Access Audit Site Report

Big Bend Ranch State Park
1900 South Saucedo Ranch Rd
Presidio, TX 79845
Accessibility Evaluation
Inspection Date: 09/20/2021
Inspectors: Tanya Scheibe

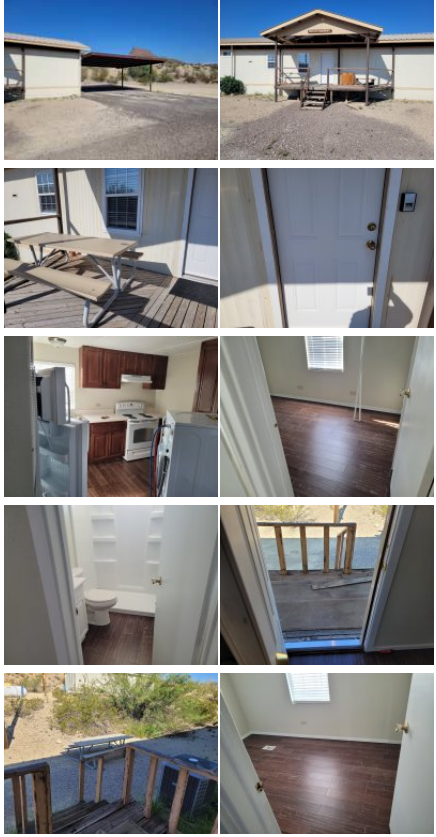
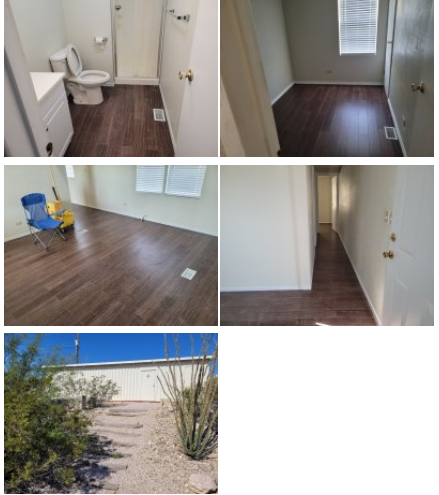
35	River District Barton Warnock Visitor Center: RD Warnock Visitor Center Women's Restroom	[29.2699233, -103.7573 692]	The compartment door is located too far from the partition or wall. The door shall be located in front of the clear space and diagonal to the water closet. Where located in the front partition, the door opening shall be 4 inches maximum from the side wall or partition farthest from the water closet. Where located in the side wall or partition, the door opening shall be 4 inches maximum from the front partition. Toilet compartment doors shall not swing into the minimum required compartment area.	4.25" from wall to edge of stall	Rehang stall door to be max 4" from adjacent stall partition and on the stall wall farthest from the toilet	2015 ABAAS Section: 604.8.1.2 2012 TAS Section: 604.8.1.2 2010 ADAS Section: 604.8.1.2

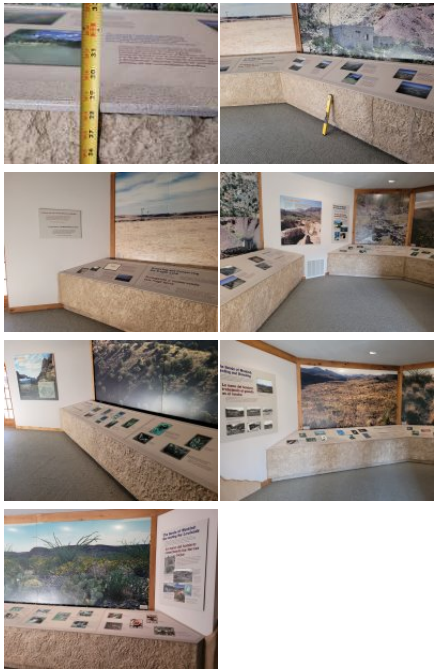
45	River District Barton Warnock Visitor Center: RD Barton Warnock Residences	[29.2697034 , -103.75726 2]	Accessible routes shall coincide with or be located in the same area as general circulation paths. Where circulation paths are interior, required accessible routes shall also be interior.	Residence at visitor center is vacant, gravel drive, step to enter front door, knobs, narrow doors, flush entry at courtyard	Provide and accessible route through the building that coincides with the general circulation path. Create AR with crushed and compacted stone or similar outdoor material from parking or sidewalk to the residence Repair, bevel, or ramp CIL along AR	2015 ABAAS Section: F206.3 2012 TAS Section: 206.3 2010 ADAS Section: 206.3

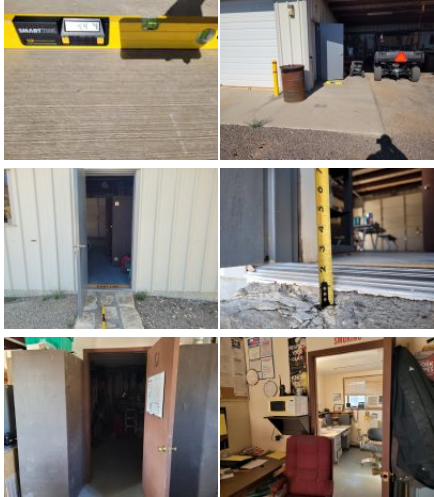
Finding Number	Area Description	Lat/Long	Finding	As Built	Recommendation	Citation	Photos	Figure
54	River District Barton Warnock Visitor Center: RD Warnock One Land Exhibit	[29.26966, -103.7576]	The door opening does not provide at least 32 inches between the face of the door and the opposite stop. Door openings shall provide a clear width of 32 inches minimum. Clear openings of doorways with swinging doors shall be measured between the face of the door and the stop, with the door open 90 degrees. There shall be no projections into the required clear opening width lower than 34 inches above the finish floor or ground. Projections into the clear opening width between 34 inches and 80 inches above the finish floor or ground shall not exceed 4 inches.	Exit door- 28.25" wide	Replace door with one having 32" clear width	2015 ABAAS Section: 404.2.3 2012 TAS Section: 404.2.3 2010 ADAS Section: 404.2.3		 Hinged Door or Gate

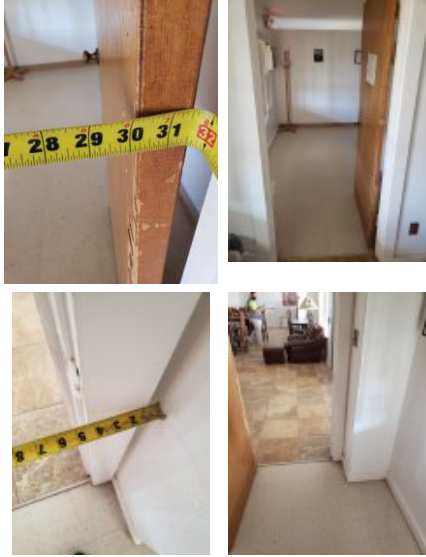
272	Interior District Saucedo - Bob Armstrong Visitor Center: ID Saucedo Women's Restroom	[29.4704354 , -103.9579 985]	Where a seat is provided in a standard roll-in shower compartment, it shall be a folding type, shall be installed on the side wall adjacent to the controls, and shall extend from the back wall to a point within 3 inches (75 mm) of the compartment entry. Where a seat is provided in an alternate roll-in type shower compartment, it shall be a folding type, shall be installed on the front wall opposite the back wall, and shall extend from the adjacent side wall to a point within 3 inches (75 mm) of the compartment entry. In transfer-type showers, the seat shall extend from the back wall to a point within 3 inches (75 mm) of the compartment entry. The top of the seat shall be 17 inches (430 mm) minimum and 19 inches (485 mm) maximum above the bathroom finish floor. Seats shall comply with 610.3.1 or 610.3.2.	7" from edge of wall to edge of seat	Provide the correct seat based on shower type.	2015 ABAAS Section: 610.3 2012 TAS Section: 610.3 2010 ADAS Section: 610.3

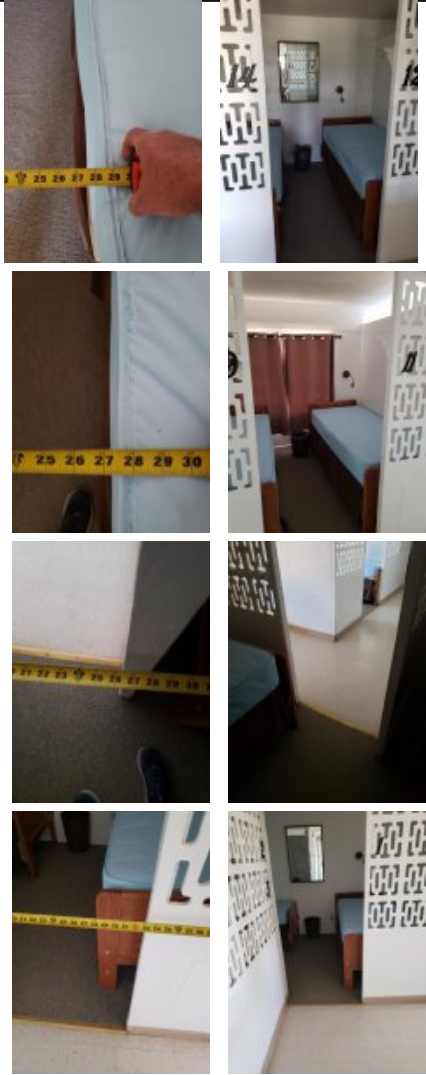
275	Interior District Saucedo - Bob Armstrong Visitor Center: ID Saucedo Parking	[29.47037, -103.9578]	The access aisle is missing at the accessible parking stall. Access aisles serving parking spaces shall adjoin an accessible route. Two parking spaces shall be permitted to share a common access aisle.	No marked aisle, gravel surface	Create one or more 8' accessible parking stalls, with one 5' adjacent access aisle, with proper signage and striping. Cost included in previous finding	2015 ABAAS Section: 502.3.1 2012 TAS Section: 502.3.1 2010 ADAS Section: 502.3.1

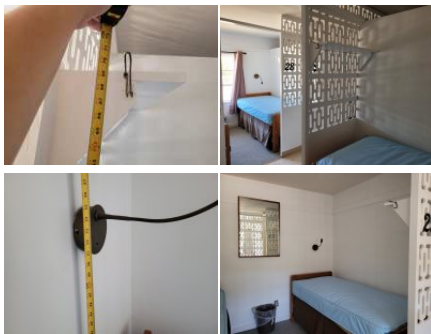
288	Interior District Sauceda - Bob Armstrong Visitor Center: ID Sauceda Men's Bunkhouse	[29.4689969, -103.9568666]	There are no accessible bathing or shower facilities. Where facilities for bathing are provided for the public, clients or employees, including showers or bathtubs, at least one shower or bathtub and support facilities such as lockers, and not less than 1 percent of all facilities, shall be accessible.	No accessible shower	Create an accessible shower in locker/bathing room	2015 ABAAS Section: F213.3.6 2012 TAS Section: 213.3.6 2010 ADAS Section: 213.3.6

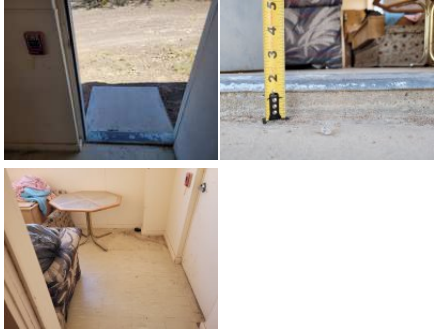
Finding Number	Area Description	Lat/Long	Finding	As Built	Recommendation	Citation	Photos	Figure
299	Interior District Saucedo - Bob Armstrong Visitor Center: ID Saucedo Women's Bunkhouse	[29.46899, -103.956893 1]	The mirror is mounted too high. Mirrors not located above lavatories or countertops shall be installed with the bottom edge of the reflecting surface 35 inches maximum above the finish floor or ground.	Mirrors provided in bunk spaces high	Lower mirror not over a sink or counter to max 35" AFF to the reflective surface	2015 ABAAS Section: 603.3 2012 TAS Section: 603.3 2010 ADAS Section: 603.3		 <p>Mirror</p> <p>If mounted over a counter or lavatory 40 inches max. to the bottom of the reflecting surface, 35 inches max if not mounted over a counter or lavatory</p>
300	Interior District Saucedo - Bob Armstrong Visitor Center: ID Saucedo Women's Bunkhouse	[29.4689596, -103.9568451]	There are no accessible bathing or shower facilities. Where facilities for bathing are provided for the public, clients or employees, including showers or bathtubs, at least one shower or bathtub and support facilities such as lockers, and not less than 1 percent of all facilities, shall be accessible.	No accessible shower	Create an accessible shower in locker/bathing room	2015 ABAAS Section: F213.3.6 2012 TAS Section: 213.3.6 2010 ADAS Section: 213.3.6

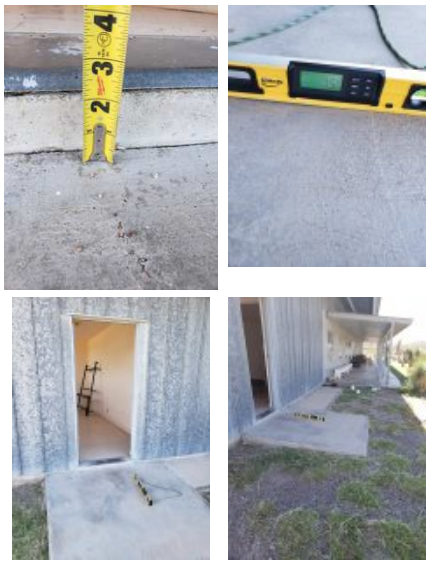
315	Interior District Saucedo - Bob Armstrong Visitor Center: ID Saucedo Bunkhouse Common Spaces	[29.4689023, -103.9570389]	Minimum maneuvering clearances at doors and gates shall comply with 404.2.4. Maneuvering clearances shall extend the full width of the doorway and the required latch side or hinge side clearance. Door openings shall provide a clear width of 32 inches (815 mm) minimum. Clear openings of doorways with swinging doors shall be measured between the face of the door and the stop, with the door open 90 degrees. Openings more than 24 inches (610 mm) deep shall provide a clear opening of 36 inches (915 mm) minimum. There shall be no projections into the required clear opening width lower than 34 inches (865 mm) above the finish floor or ground. Projections into the clear opening width between 34 inches (865 mm) and 80 inches (2030 mm) above the finish floor or ground shall not exceed 4 inches (100 mm). The threshold has a vertical change greater than	Kitchen exit- 1" threshold, no egress	For all doors along the public circulation route, provide required maneuvering clearance on push and pull side of doors For all doors along the public circulation route, replace doors with doors having 80" overhead clearance and 32" clear width For all doors along the public circulation route, repair, bevel, or ramp CILs at door entries to max .25" For all doors along the public circulation route, repair, provide beveled threshold For all doors along the public circulation route, inspect, adjust, and maintain 5 lbf to open interior doors For all doors along the public circulation route, inspect, adjust, and maintain closing speed on door closers For all doors along the public circulation route, inspect, adjust, and maintain 8.5 lbf to open exterior doors as a smart practice For all doors along the public circulation route, replace hardware with lever hardware or hardware operable	2010 ADAS Section: 404.2.3, 404.2.7, 404.2.4, 404.2.11, 404.2.11 Exception

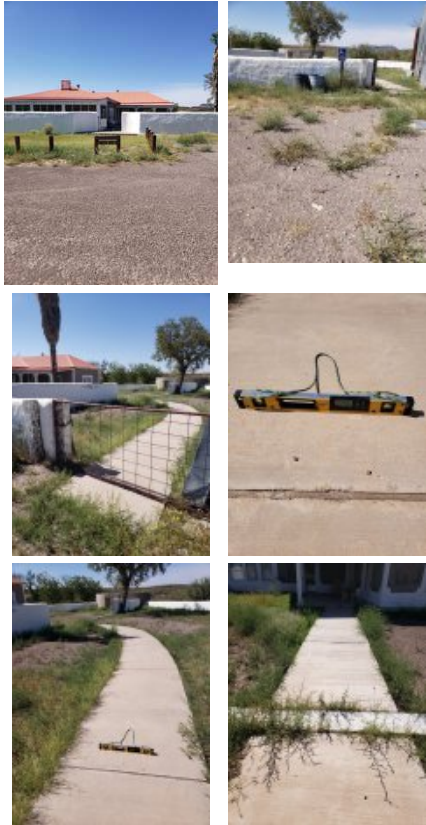
Finding Number	Area Description	Lat/Long	Finding	As Built	Recommendation	Citation	Photos	Figure
321	Interior District Saucedo - Bob Armstrong Visitor Center: ID Saucedo Bunkhouse Common Spaces	[29.4689596, -103.9569846]	The U-shaped kitchen is not wide enough. In U-shaped kitchens enclosed on three contiguous sides, clearance between all opposing base cabinets, counter tops, appliances, or walls within kitchen work areas shall be 60 inches.	54.5" wide kitchen work area	Renovate U shaped kitchen to provide required 60" clearance between cabinets, counter tops and appliances	2015 ABAAS Section: 804.2.2 2012 TAS Section: 804.2.2 2010 ADAS Section: 804.2.2

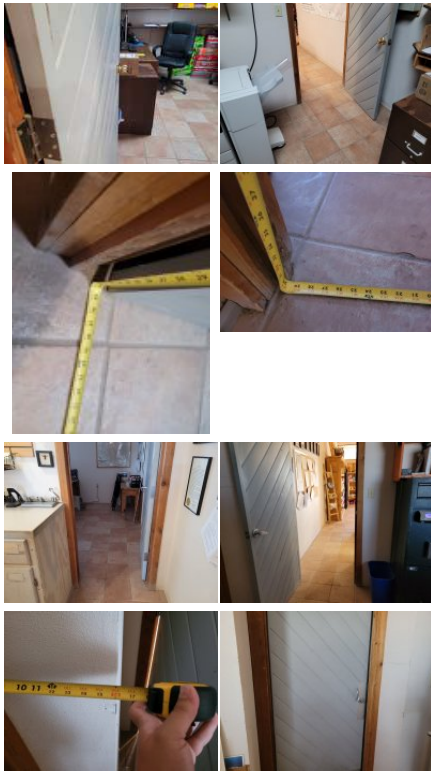
Finding Number	Area Description	Lat/Long	Finding	As Built	Recommendation	Citation	Photos	Figure
322	Interior District Sauceda - Bob Armstrong Visitor Center: ID Sauceda Bunkhouse Common Spaces	[29.4689315, -103.9570114]	The sink is not accessible. A clear floor space at least 30 inches by 48 shall be provided in front of a sink to allow forward approach. -The clear floor space shall be on an accessible route and shall extend a maximum of 19 inches underneath the sink. -Sinks shall be mounted with the counter or rim no higher than 34 inches above the finish floor. -Knee clearance at least 27 inches high, 30 inches wide and 19 inches deep shall be provided.	The only sink is not accessible	Acquire a shallower model sink bowl to provide 27" knee clearance	<p>2015 ABAAS Section: 606.2, 606.2 EXCEPTION S: 1, 606.2 EXCEPTIONS: 4, 606.2 EXCEPTIONS: 5, 606.2 EXCEPTIONS: 6, 606.2 EXCEPTIONS: 7, 606.3, 606.4, 606.5</p> <p>2012 TAS Section: 606.2, 606.2 Exception 1, 606.2 Exception 4, 606.2 Exception 5, 606.2 Exception 6, 606.2 Exception 7, 606.3, 606.4, 606.5</p> <p>2010 ADAS Section: 606.2, 606.2 Exception 1, 606.2 Exception 4, 606.2 Exception 5, 606.2 Exception 6, 606.2 Exception 7, 606.3, 606.4, 606.5</p>

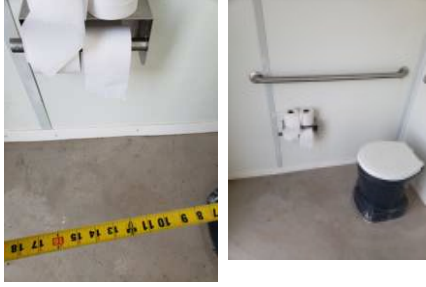
Finding Number	Area Description	Lat/Long	Finding	As Built	Recommendation	Citation	Photos	Figure
369	Interior District Papalote Encino: ID Papalote Encino Camping	[29.5035656 , -103.8929 391]	Camping facilities shall provide camping units with mobility features complying with F244.2 in accordance with Table F244.2. Where a camping facility provides different types of camping units, Table F244.2 shall apply to each type of camping unit provided. Total Number of Camping Units Provided in Camping Facility Minimum Number of Camping Units with Mobility Features Required 1 1 2 to 25 2 26 to 50 3 51 to 75 4 76 to 100 5 101 to 150 7 151 to 200 8 201 and over 8, plus 2 percent of the number over 200	No accessible route to table, grill, or bear box	Create the required number of accessible camp sites per table F244.2 as a smart practice	2015 ABAAS Section: F244.2

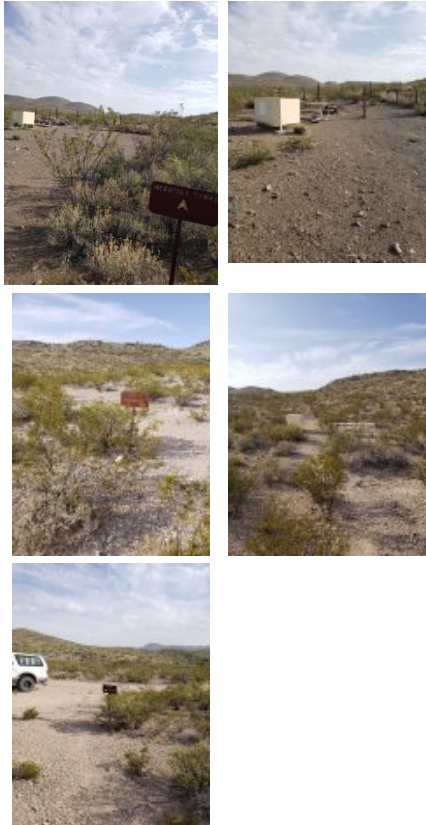
Finding Number	Area Description	Lat/Long	Finding	As Built	Recommendation	Citation	Photos	Figure
378	Interior District Pila Montoya 1, 2, 3: ID Pila Montoya Restroom	[29.4924454, -103.8600107]	<p>Minimum maneuvering clearances at doors and gates shall comply with 404.2.4. Maneuvering clearances shall extend the full width of the doorway and the required latch side or hinge side clearance. Door openings shall provide a clear width of 32 inches (815 mm) minimum. Clear openings of doorways with swinging doors shall be measured between the face of the door and the stop, with the door open 90 degrees. Openings more than 24 inches (610 mm) deep shall provide a clear opening of 36 inches (915 mm) minimum. There shall be no projections into the required clear opening width lower than 34 inches (865 mm) above the finish floor or ground. Projections into the clear opening width between 34 inches (865 mm) and 80 inches (2030 mm) above the finish floor or ground shall not exceed 4 inches (100 mm). The threshold has a vertical change greater than 1/4 inch high. The threshold at a doorway shall be no higher than 1/2 inch. Changes in level between 1/4 inch and 1/2 inch must be beveled at 1:2 or less. 1/4 inch is the maximum vertical rise. All interior doors must be maintained so that the operating pressure does not exceed 5 lb. force to open. The sweep period for doors with closers shall be adjusted so that from an open position of 70 degrees, the door will take at least 3 seconds to move to a point 3 inches from the latch, measured to the leading edge of the door. Exterior doors are recommended to be maintained at 8.5 lbf as a smart practice. Force is to be measured at the operating hardware or 30 inches from the hinges, whichever is greater. Hand-activated door opening hardware, handles, pulls, latches, locks, and other operating devices on accessible doors shall have a shape that is easy to grasp with one hand and does not require tight grasping, tight pinching or twisting of the wrist to operate. Hardware shall be 34 inches minimum and 48 inches maximum above the finish floor or</p>	6" CIL at door, door has knobs on both sides	For all doors along the public circulation route, repair, bevel, or ramp CILs at door entries to max .25" For all doors along the public circulation route, replace hardware with lever hardware or hardware operable without a tight pinch or grasp	2010 ADAS Section: 404.2.3, 404.2.7, 404.2.4, 404.2.11, 404.2.11 Exception

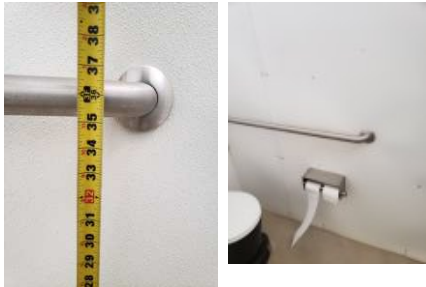
Finding Number	Area Description	Lat/Long	Finding	As Built	Recommendation	Citation	Photos	Figure
379	Interior District Fresno Vista: ID Fresno Vista Camping	[29.499306, -103.85152 53]	Camping facilities shall provide camping units with mobility features complying with F244.2 in accordance with Table F244.2. Where a camping facility provides different types of camping units, Table F244.2 shall apply to each type of camping unit provided. Total Number of Camping Units Provided in Camping Facility Minimum Number of Camping Units with Mobility Features Required 1 1 2 to 25 2 26 to 50 3 51 to 75 4 76 to 100 5 101 to 150 7 151 to 200 8 201 and over 8, plus 2 percent of the number over 200	lacks accessible primitive campsite, unable to access this location at time of audit	Create the required number of accessible camp sites per table F244.2 as a smart practice	2015 ABAAS Section: F244.2

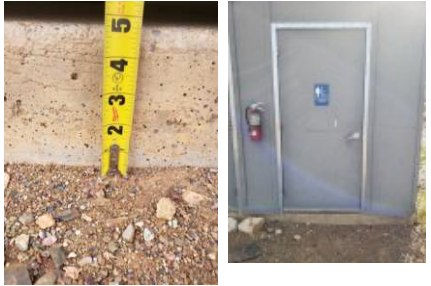
Finding Number	Area Description	Lat/Long	Finding	As Built	Recommendation	Citation	Photos	Figure
382	Interior District McGuirk's Tanks, Paso al Solitario: ID McGuirk's Tanks, Paso al Solitario Camping	[29.4706619, -103.8175205]	Camping facilities shall provide camping units with mobility features complying with F244.2 in accordance with Table F244.2. Where a camping facility provides different types of camping units, Table F244.2 shall apply to each type of camping unit provided. Total Number of Camping Units Provided in Camping Facility Minimum Number of Camping Units with Mobility Features Required 1 1 2 to 25 2 26 to 50 3 51 to 75 4 76 to 100 5 101 to 150 7 151 to 200 8 201 and over 8, plus 2 percent of the number over 200	McGuirks Tanks, Paso al Solitario- these campsites had no accessible route to site features	Create the required number of accessible camp sites per table F244.2 as a smart practice	2015 ABAAS Section: F244.2
